SUBJECT: Grand Gulf Nuclear Station, Unit 1
Docket No. 50-416
Supplement to Amendment Request
Response to Request for Additional Information Concerning New
Special Operations LIMITING CONDITION FOR OPERATION
Suppression Pool Makeup-MODE 3 (LDC 2002-006)

**Response to Request for Additional Information
GRAND GULF TAC MB4260**

Attachment 2 - Response to Questions 19(a) and 19(c)
Calculation of UCP and Suppression Pool Level Curves for
Proposed Technical Specification Figure 3.10.9-1

Figure 2

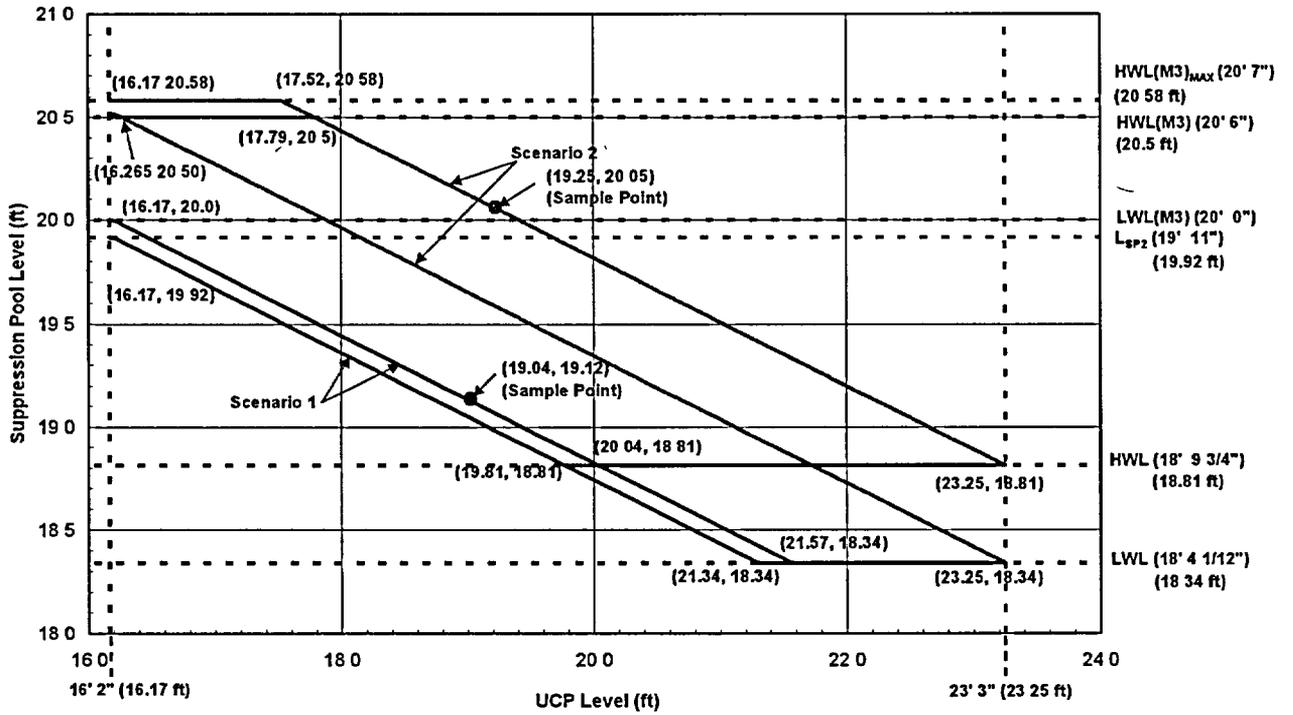
- c. **Also, please provide a sample calculation for a point on the inclined portion of the upper and the lower curves of TS Figure 3.10.9-1.**

This sample calculation uses the equations derived above for Scenario 1 to calculate a point at 19.0396 ft (19' - 0.48") UCP level on the lower curve of Figure 3.10.9-1.

This point (19.04 ft UCP level, 19.12 ft suppression pool level) is identified on attached Figure 2.

This sample calculation uses the equations derived above for Scenario 2 to calculate a point at 19.25 ft (19' - 3") UCP level on the upper curve of Figure 3.10.9-1.

This point (19.25 ft UCP level, 20.05 ft suppression pool level) is identified on attached Figure 2.
